## UNITED STATES DEPARTMENT OF THE INTERIOR BUREAU OF LAND MANAGEMENT

SUNDRY NOTICES AND REPORTS ON WELLS

## **EIGHT POINT DRILLING PLAN**

#### DRILLING CONDITIONS OF APPROVAL

## **CLASS III BOP SCHEMATIC**

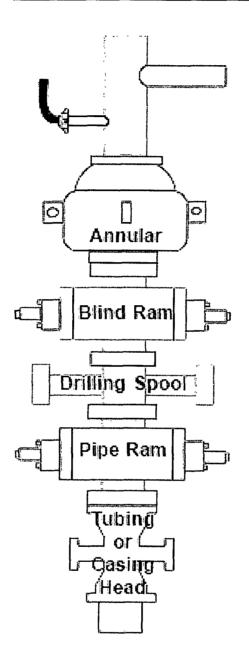
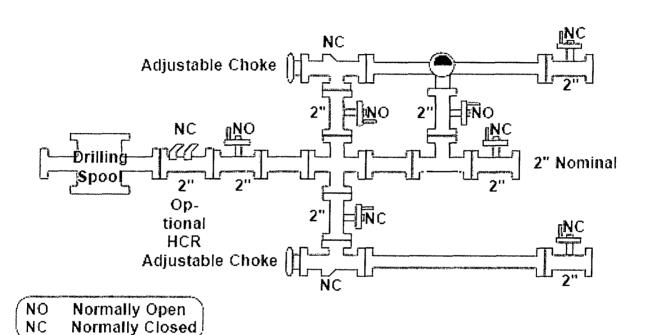
II. Since no BOPE test pressures were proposed, it is recommended that Chevron MidContinent L.P. test the BOP and related equipment according to Onshore Order No. 2 Minimum Standards and Enforcement Provisions For Well Control Equipment Testing.

\*Test BOPE to a minimum of 1000 psi based on an anticipated surface pressure of 984 psi. Report all BOPE and casing pressure test results on sundry form 3160-5.
